ADDENDUM NO. 2

VILLAGE OF COVINGTON Wastewater Treatment Plant Improvements Phase II Blower Replacement February 19, 2019

Re: Village of Covington
Wastewater Treatment Plant Improvements Phase II – Blower Replacement

NOTE:
1. SEAL OFF ANY PENETRATIONS THROUGH THE FLOOR BEFORE CONCRETE.
2. OWNER TO REMOVE INTERIOR BUILDING EQUIPMENT PRIOR TO CONSTRUCTION.

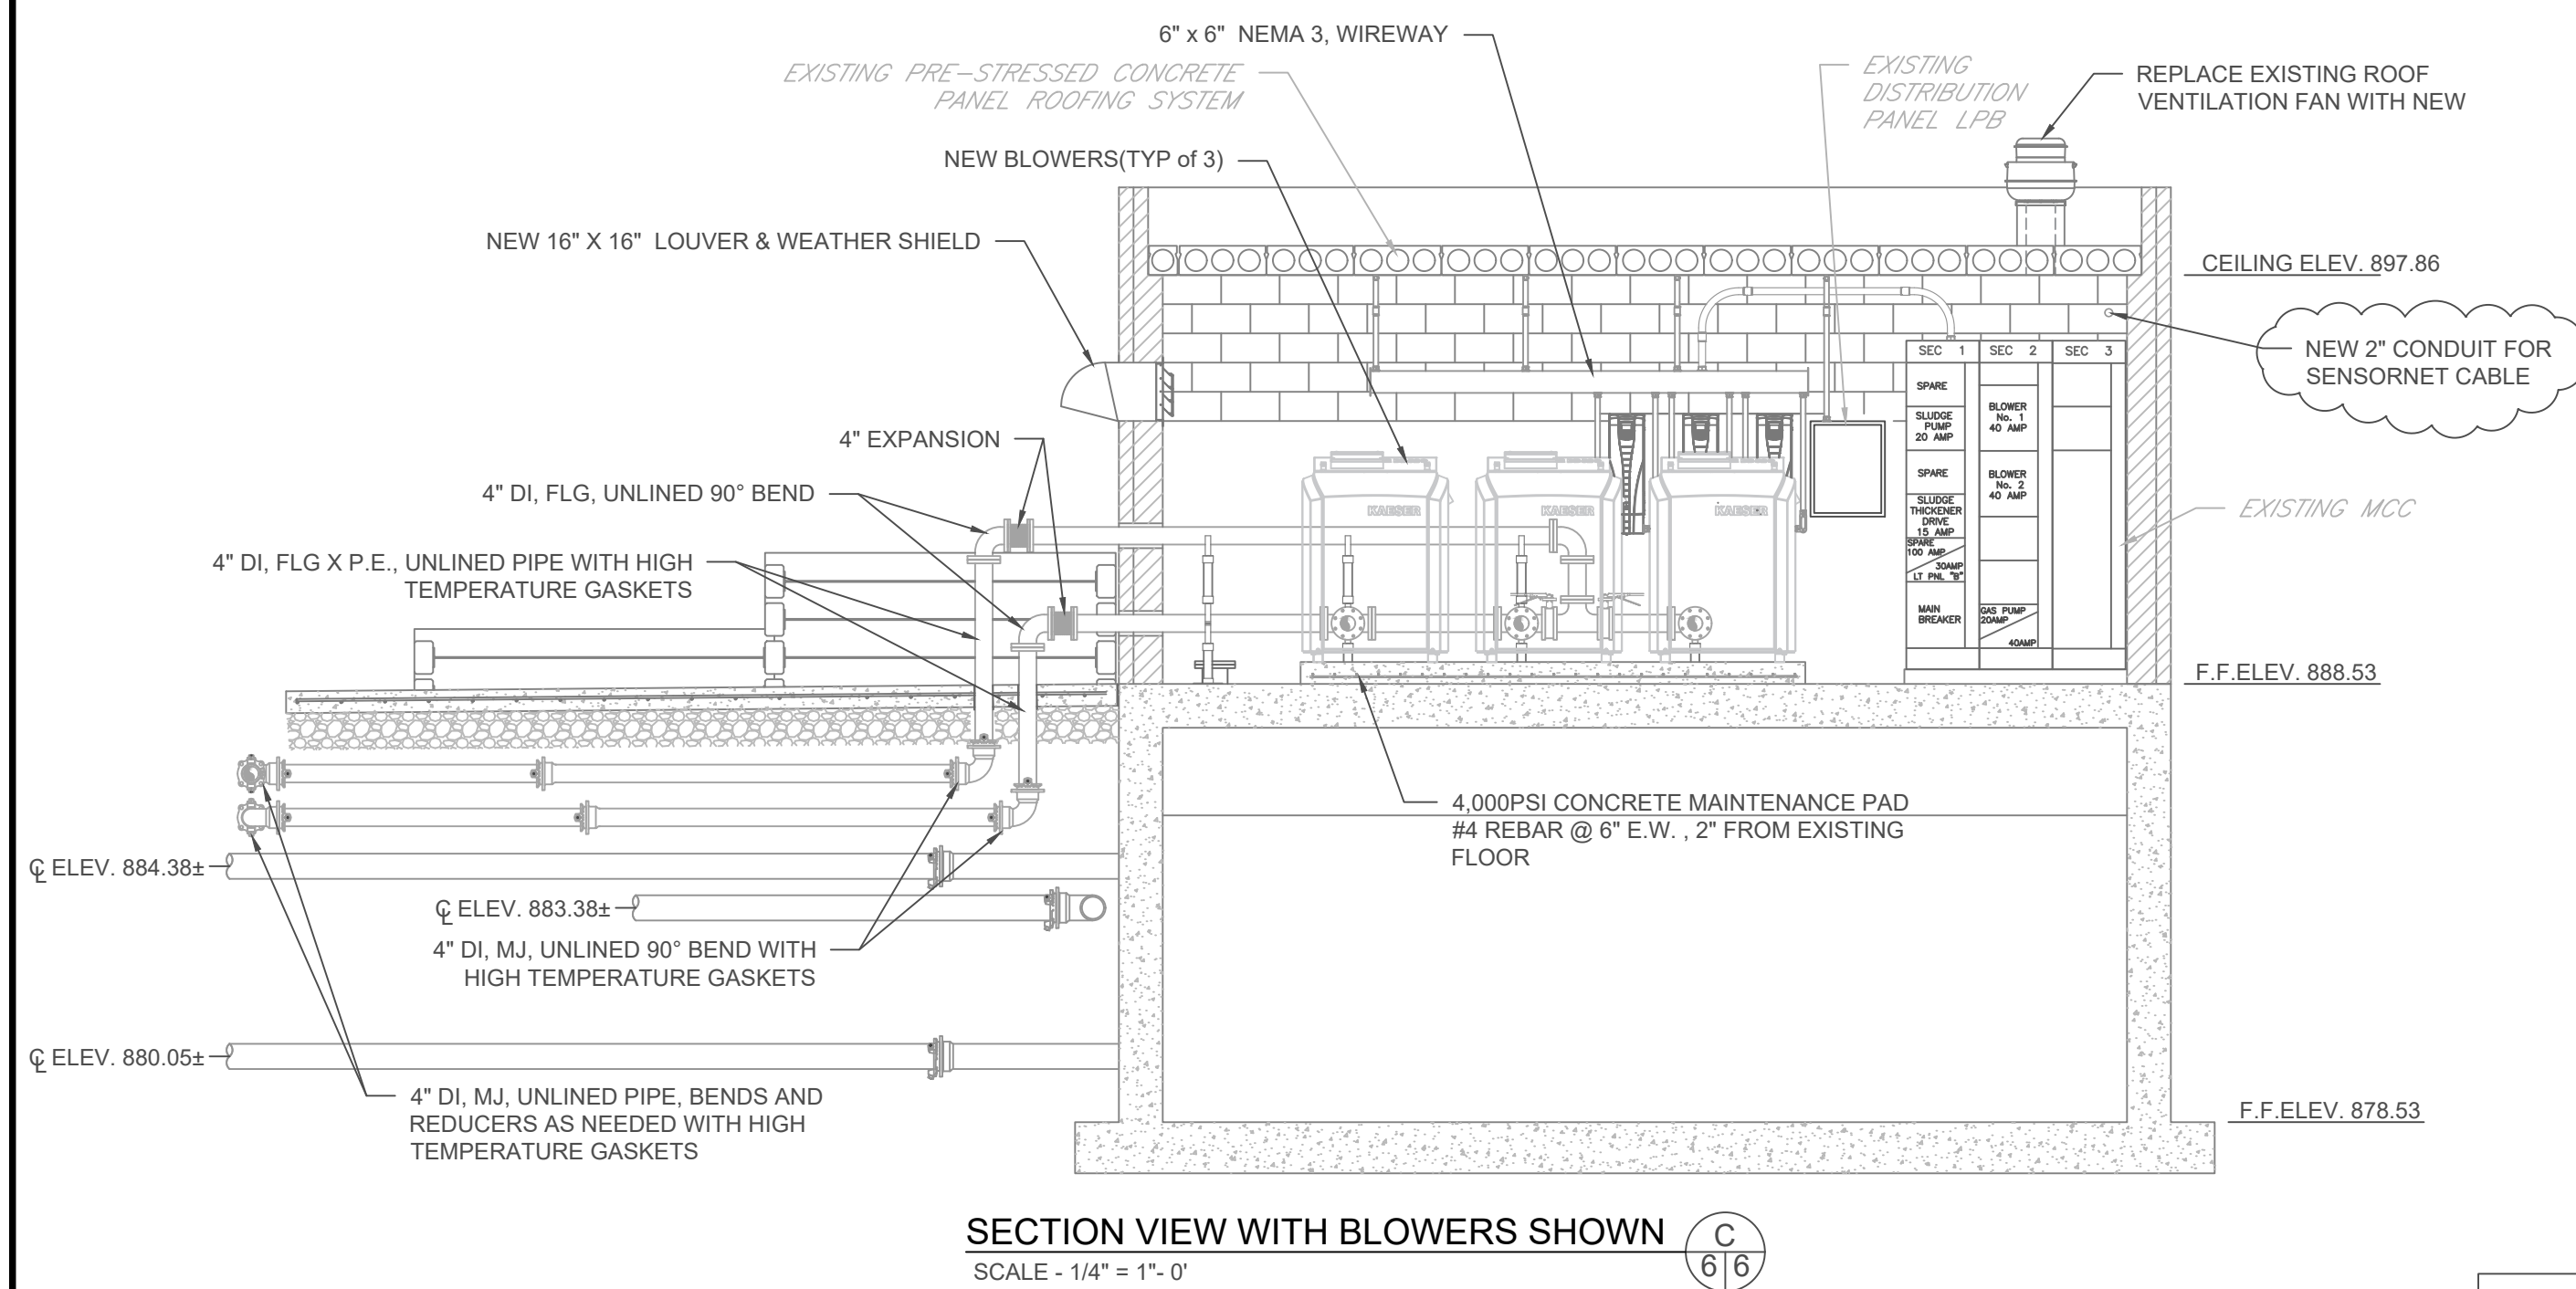
3. Sheet 2A has been updated indicated the amount of air piping to be replaced.
4. Sheets 3A, 4A, 6A, 8A and 9A indicate the changes from fiber-optic to SensorNet Cables.
5. Sheet 5A clarifies the water piping and obsolete equipment to be removed.

DRM	15 FEB 2019	REMOVE FIBER-OPTIC AND REPLACE WITH YSI SENSORNET
-----	-------------	---
